Technical Memorandum

To:	Ground-Level Monitoring Committee, Chino Basin Watermaster
From:	Wildermuth Environmental, Inc. (WEI)
Date:	December 13, 2017
Subject:	Task 3 and Task 4 of the Work Plan to Develop a Subsidence Management Plan for the Northwest MZ-1 Area: <i>Development and Evaluation of Baseline and Initial Subsidence-Management Alternatives</i>

Response to GLMC Comments

Figure 1

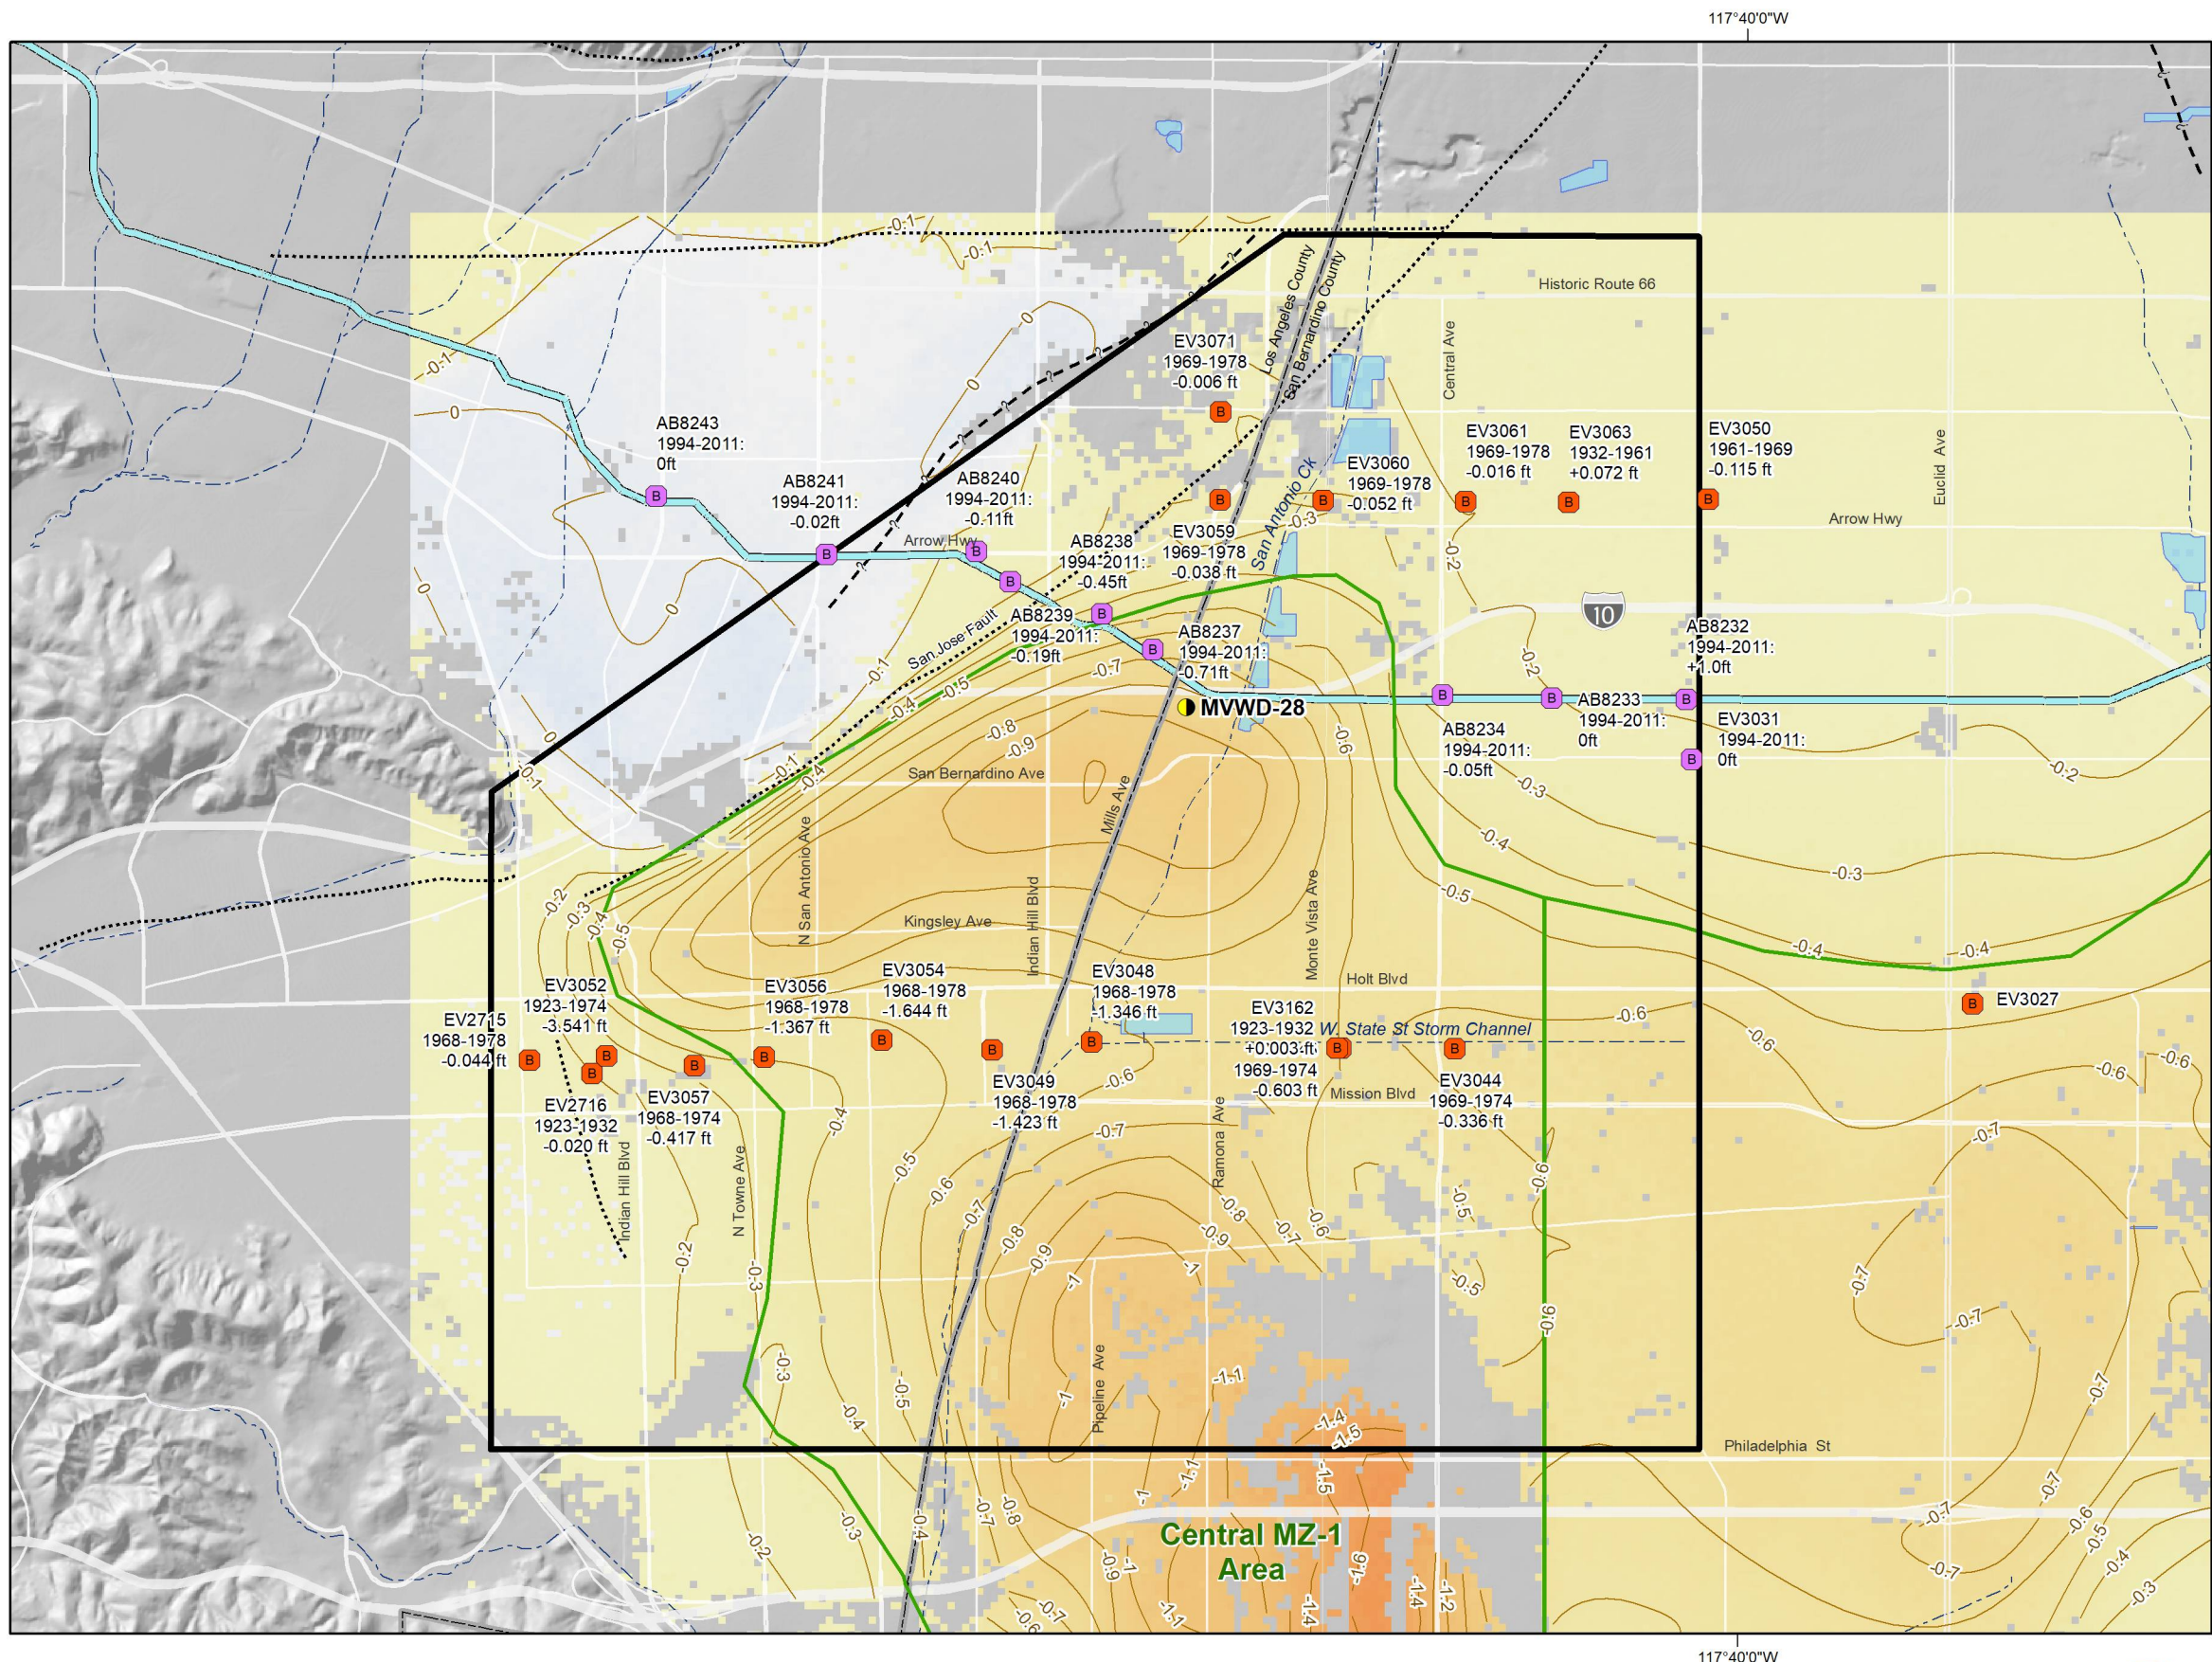
“MVWD-15 “This well is not shown on the either map figure 1 or 2. Do you mean MVWD-13? Also, Well Margarita #1 and MVWD-19 are not shown on either of the maps.

Figure 1 has been updated to include wells: MVWD-15, MVWD-19, and Margarita #1. Thank you.

Figure 4. Generalized hydrogeology of the 1D aquifer-system compaction model and grid based on the MVWD-28 lithologic and resistivity logs. Inset shows the 2-foot cell spacing used throughout the entire model.

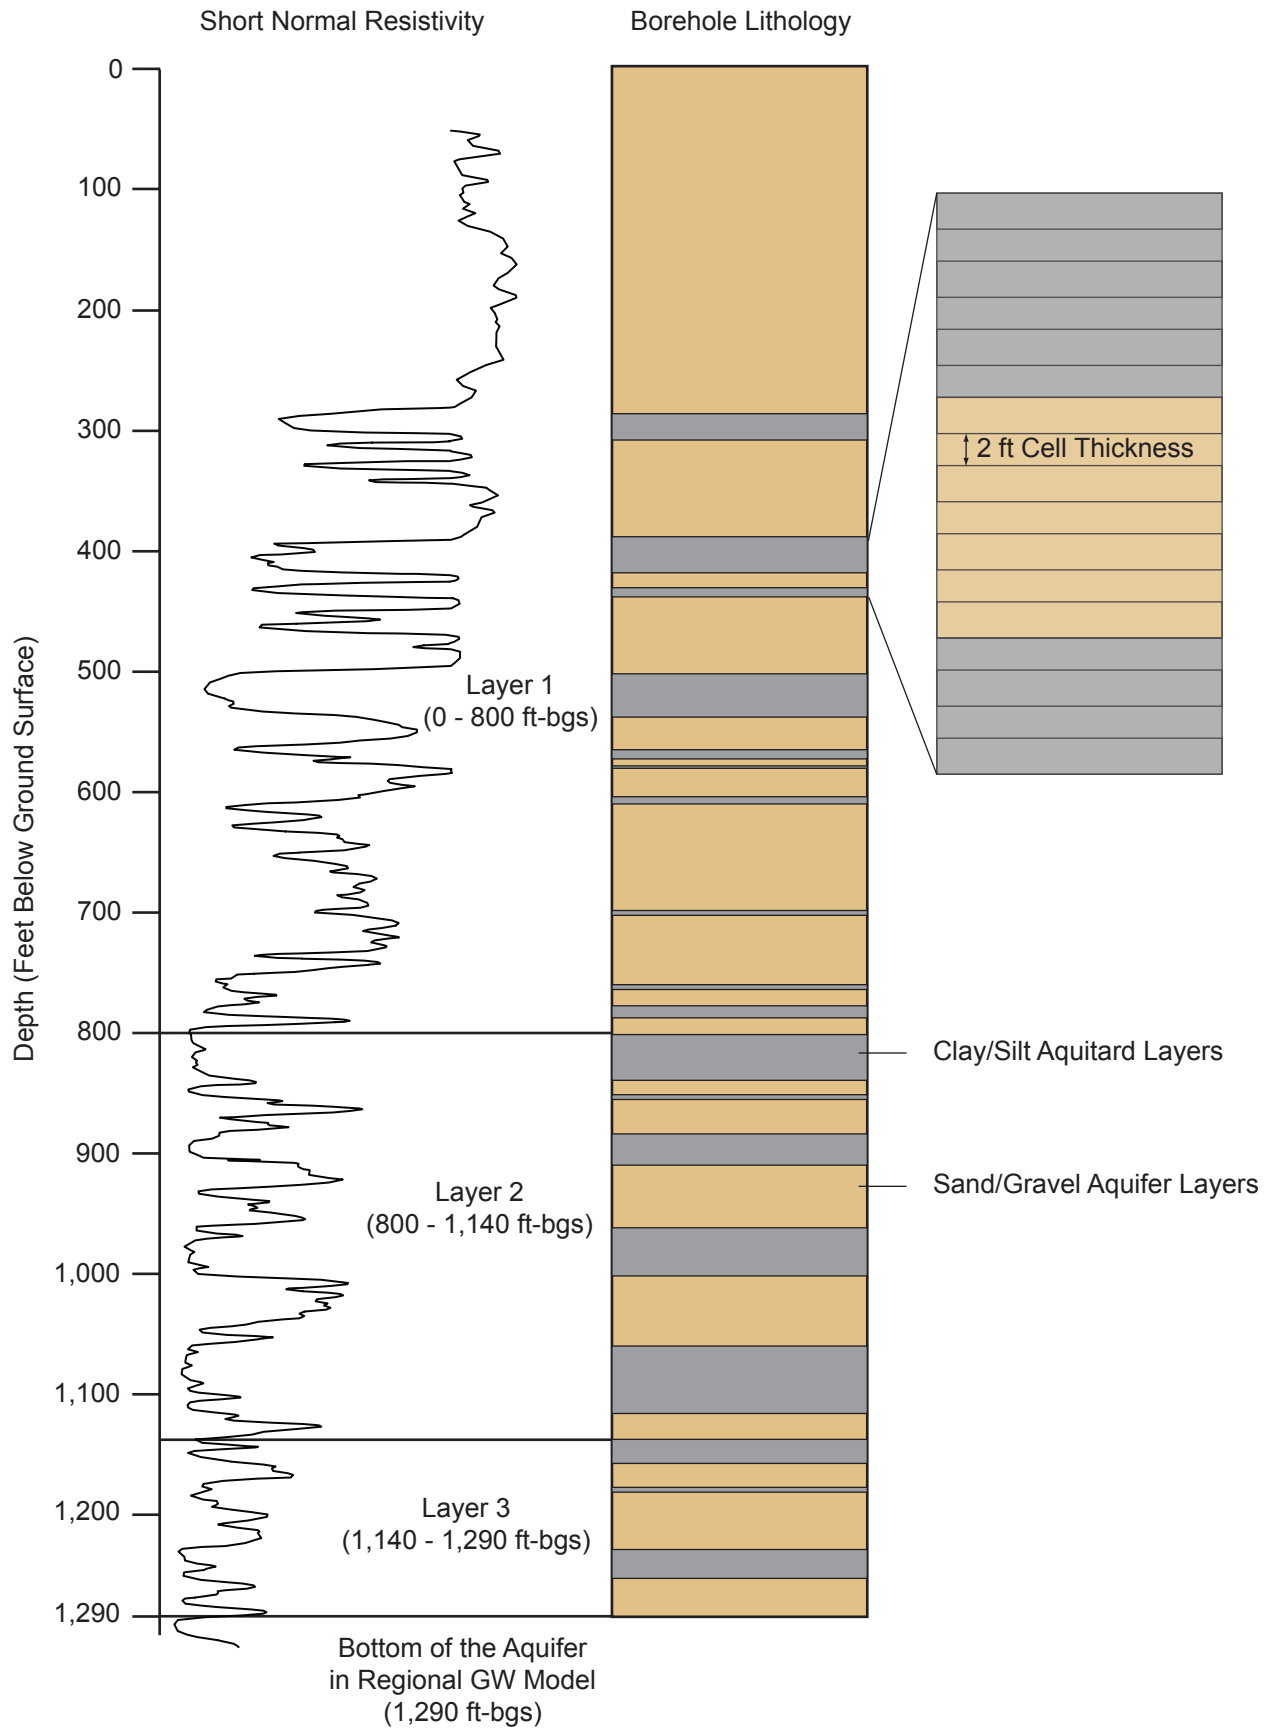
Comment 10, Figure 4:

The 1,290 ft-bgs represents the bottom of the aquifer in the Watermaster's regional MODFLOW groundwater model. A note to this effect has been added to Figure 4.

Figure 7
Model-Simulated Aquifer-System Deformation versus InSAR-Estimated Ground Motion
at the MVWD-28 Well Location for Final Calibration of the 1D Model

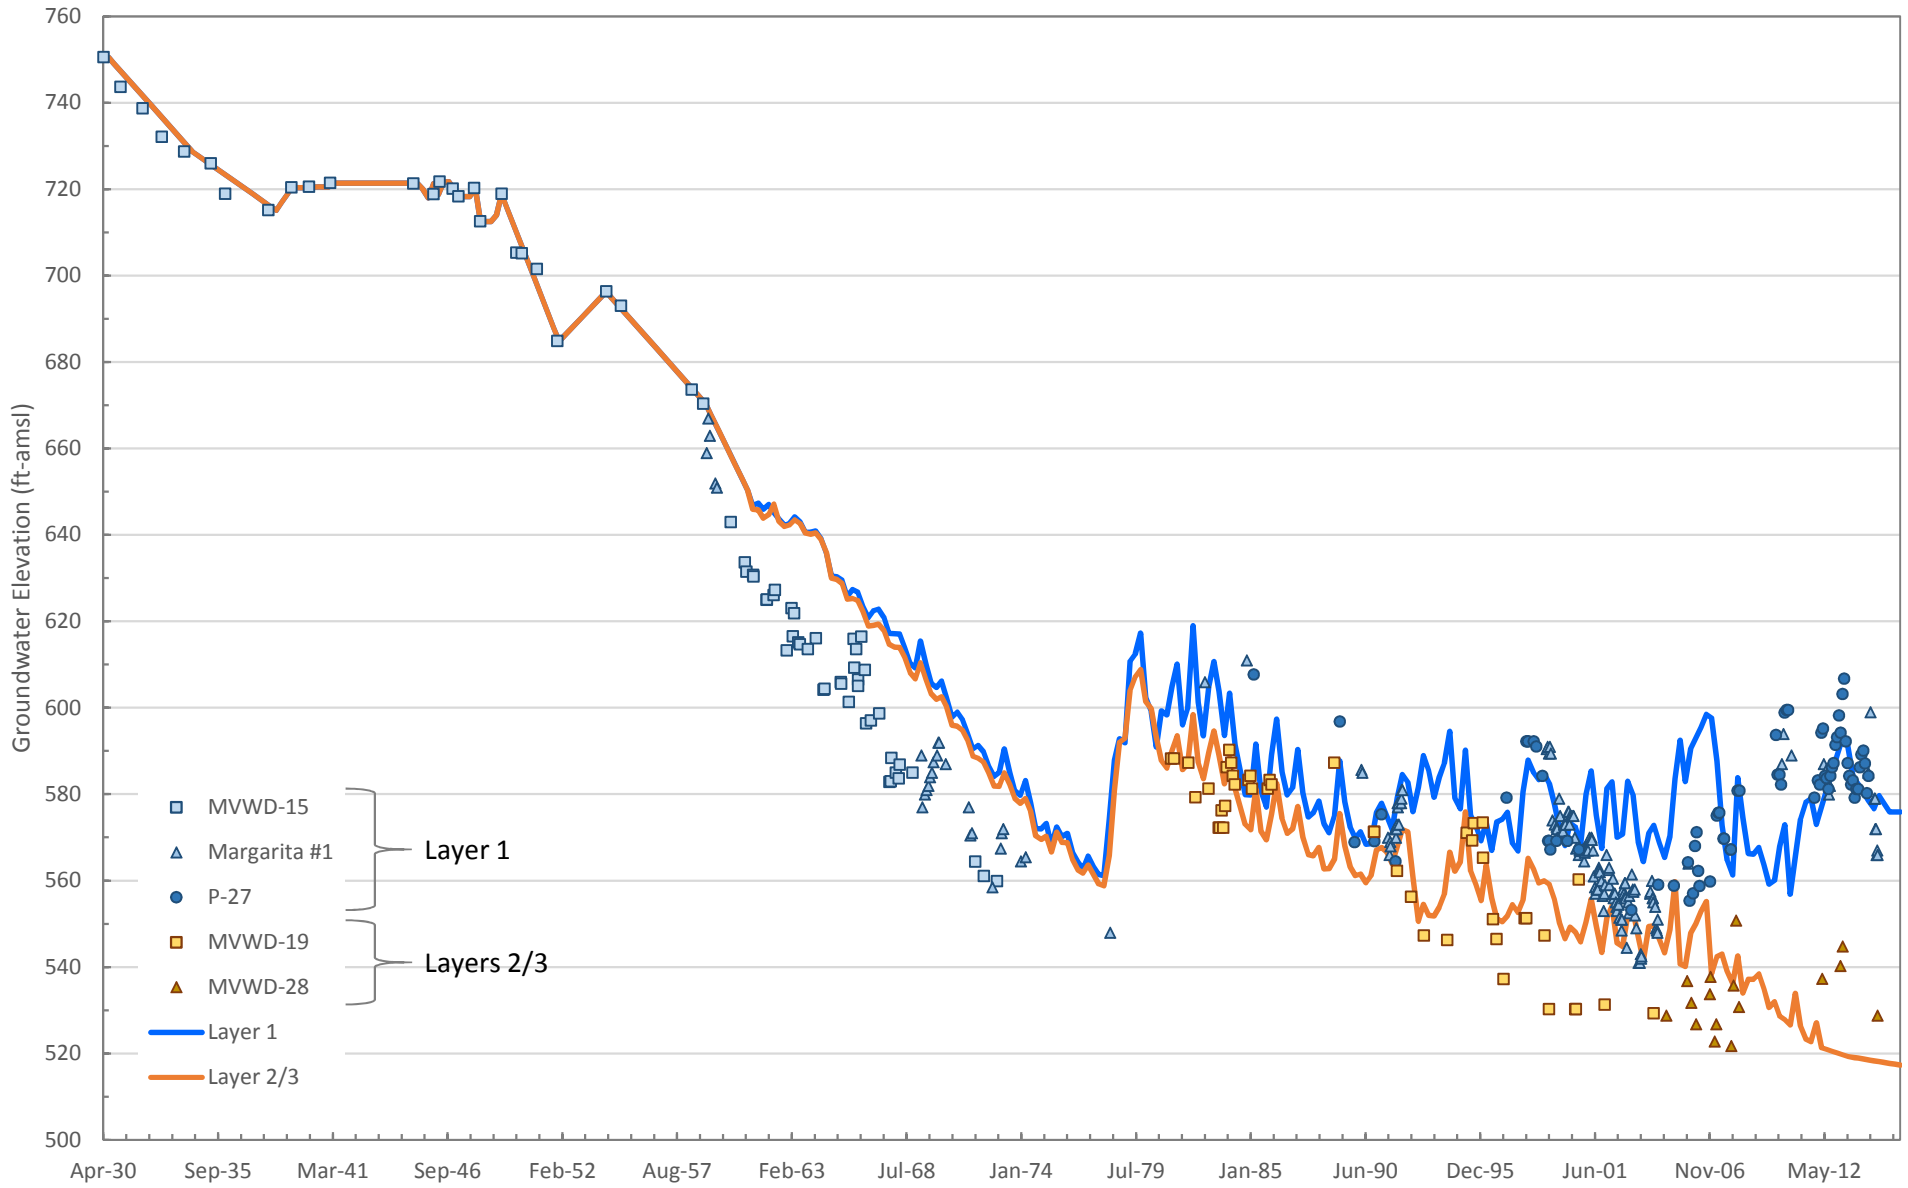
Despite the stabilization in water level trends over the last 20 to 35 years, In-SAR data shows continued subsidence through the model calibration period (WEI Figure 7, Figure 3 attached). This indicates that the subsidence occurring in the Chino Basin is delayed in its response to declining groundwater levels during the period from 1930 through 1978. This delayed subsidence was recognized on page 2 of the technical memorandum, which states that “from about 1930 to 1978, heads in Northwest MZ-1 declined by about 175 feet. Since then, heads have recovered, but have remained below the levels of 1930. The observed and continuous subsidence that occurred between the 1992 to 2016 period cannot be explained entirely by the concurrent changes in head. A plausible explanation for the subsidence is that thick, slow-draining aquitards are compacting in response to the historical head declines that occurred from 1930 (or before 1930) to 1978.” Considering the great thickness of the aquitards and the observed time lag between the recovery of groundwater levels and the ongoing occurrence of land subsidence in the study area, simulating subsidence using the 1-D Model is not suitable for this area.

Figure 9
1D Model Simulated Compaction at the MVWD-28 Well Location
1930-2015

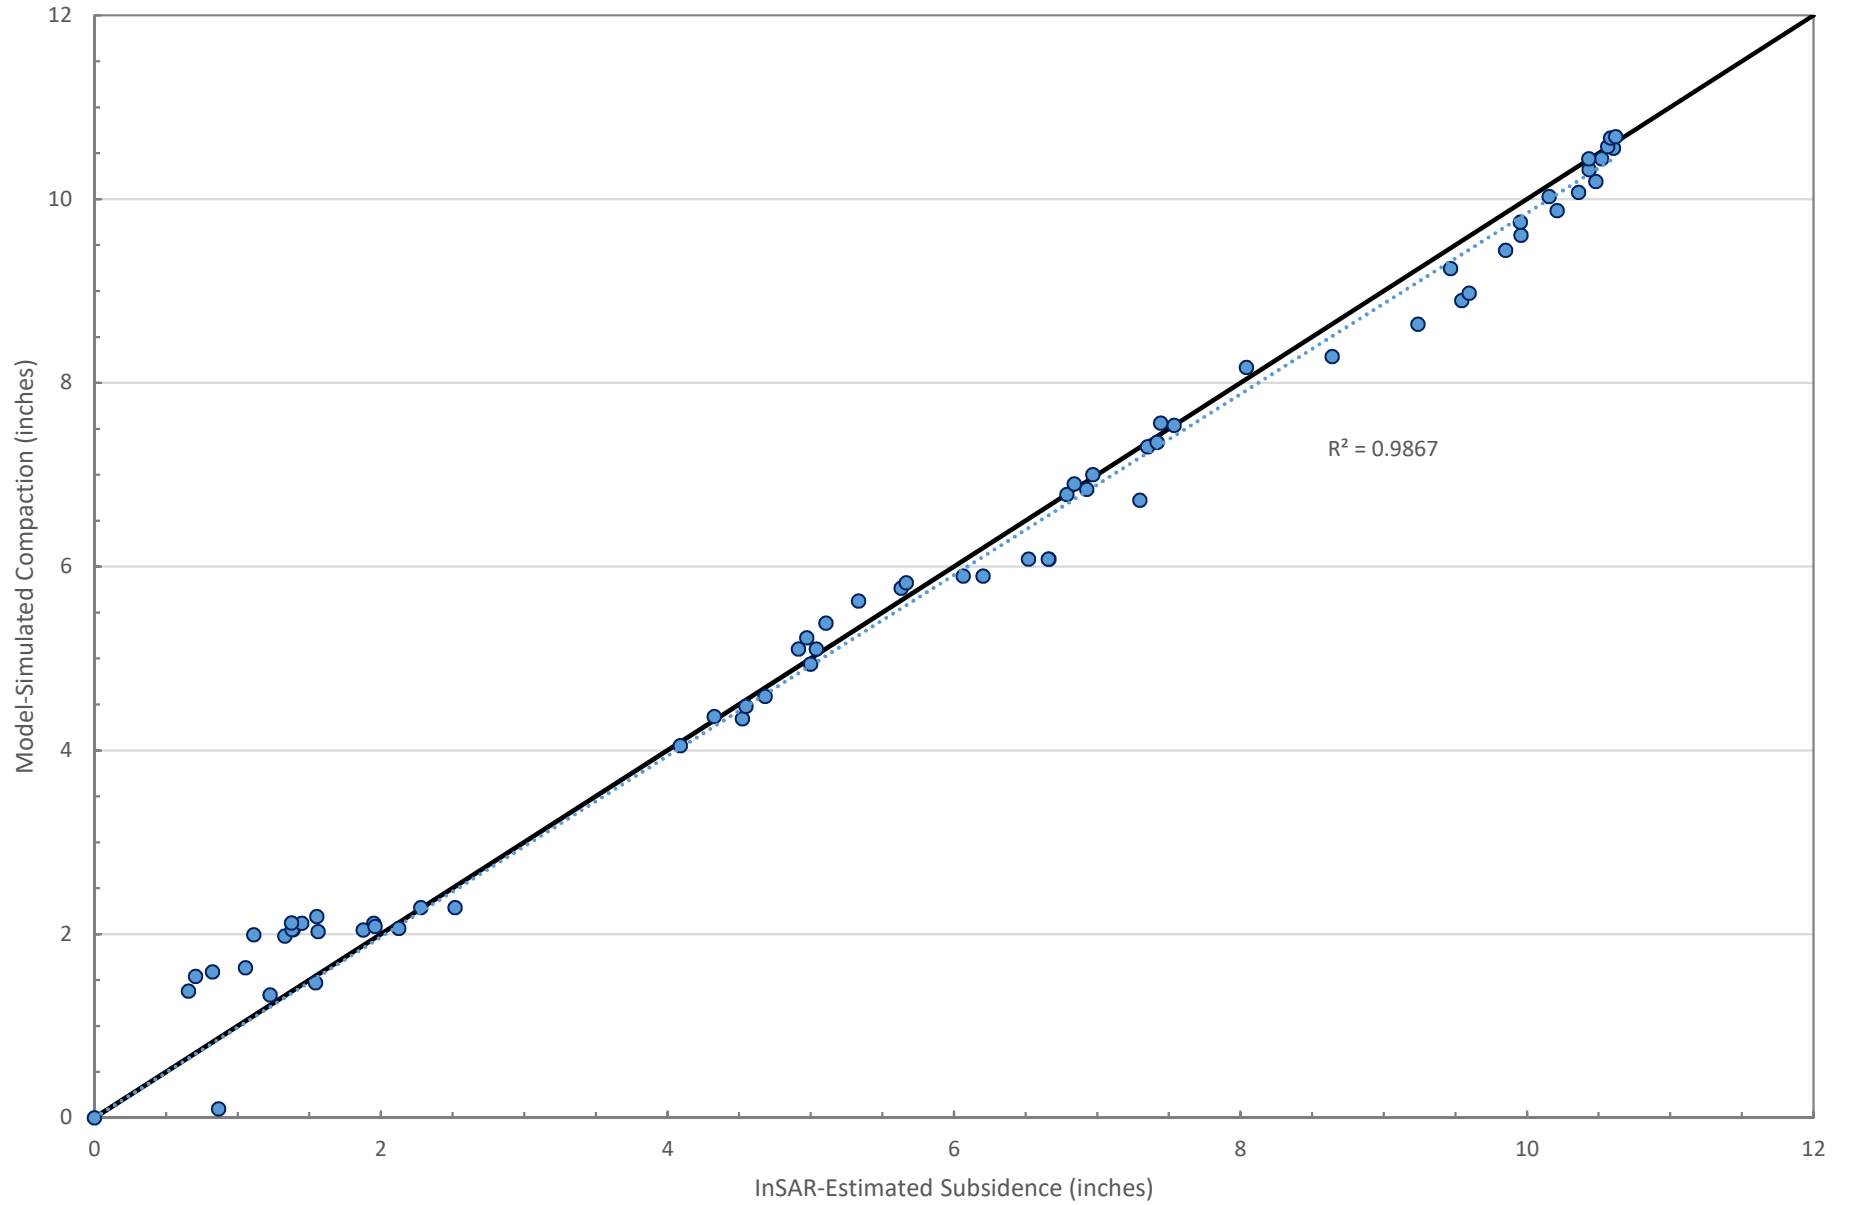
Comment 10, Under Results and Interpretations, 1-Dimensional Aquifer-System Compaction Model, Historical Subsidence Simulation, Figure 9:

On Figure 9, it would be helpful to better understand the model response to ongoing residual compaction if the modeled groundwater level and pre-consolidation hydraulic head for the layers was presented along with the simulated compaction. That is, has the rate of compaction leveled off since the mid-1970s because groundwater levels have recovered above an established pre-consolidation hydraulic head level?

Yes. Inspection of Figure 2 shows that water levels at many wells in Northwest MZ-1 declined to an all-time low by 1977, and then recovered by about 100 feet over the next 8-10 years. This is the reason for the break in slope in the model-simulated compaction curve at about 1978 on Figure 9.
